Subject ▶ Addition of Set Plate and change of Housing Set

For Models ▶ 6222D

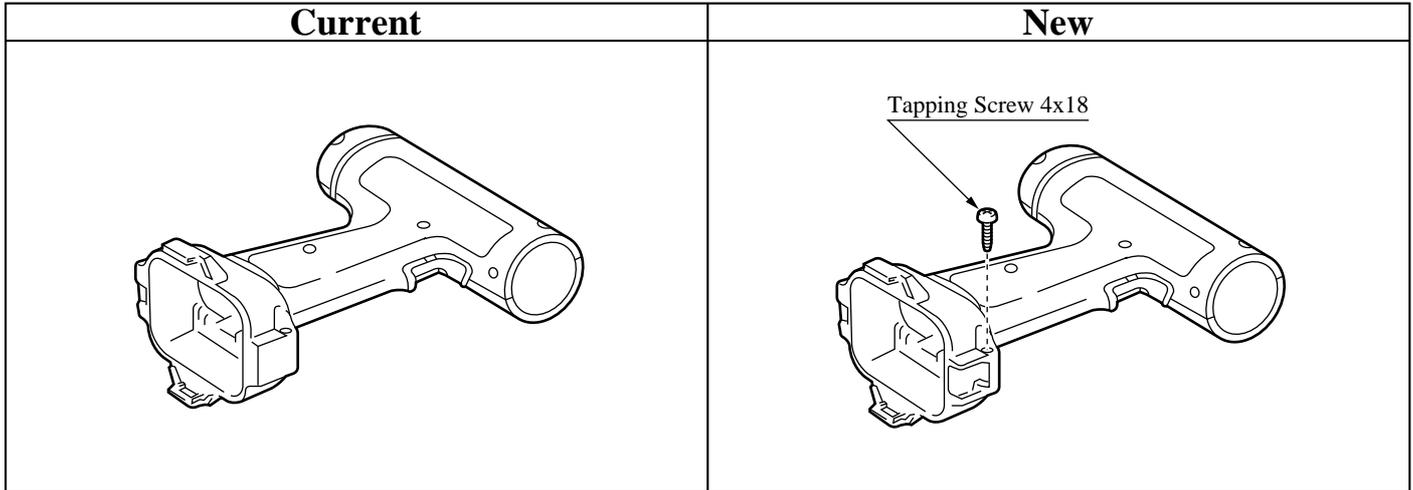
Description ▶ Set plate has been added as standard equipment, so that battery without push buttons can be used. Also as illustrated below, Housing Set and one of Tapping Screw 4x18 have been changed so that Set Plate can be attached.
